# PIC32MZ EF FAMILY

## PIC32MZ Embedded Connectivity with Floating Point Unit (EF) Family Silicon Errata and Data Sheet Clarification

The PIC32MZ Embedded Connectivity with Floating Point Unit (EF) family of devices that you have received conform functionally to the current Device Data Sheet (DS60001320D), except for the anomalies described in this document.

**FIGURE 1: POSC CRYSTAL CIRCUIT**

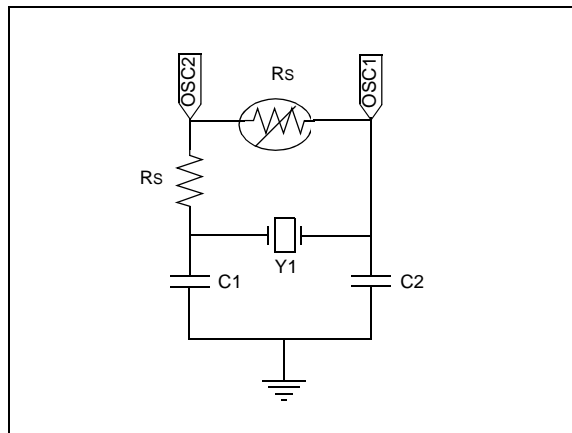
**Revision A3 Silicon:** The Posc has been tested in a normal power-up sequence and supports specific crystal operation.

The Primary Oscillator (Posc) has been characterized to operate at 8 MHz, 12 MHz, and 24 MHz when the circuit in [Figure 1](#) is implemented, and the operating conditions listed in [Table 3](#) are met.

Crystal Frequency (see Note 1)	Series Resistor (Rs)	Posc Gain Setting POSCGAIN<1:0> (DEVCFG0<20:19>)	Posc Boost Setting POSCBOOST (DEVCFG0<21>)
8 MHz	2 kΩ	'0b00 (GAIN_0)	'0b1 (ON)
12 MHz	1 kΩ	'0b00 (GAIN_0)	'0b1 (ON)
24 MHz	0 kΩ	'0b00 (GAIN_0)	'0b1 (ON)

**Note 1:** Using any other crystal frequency will require special component selection and characterization.  
**Note 2:** A shunt resistor (Rshunt) should not be used to increase the gain of the POSC.
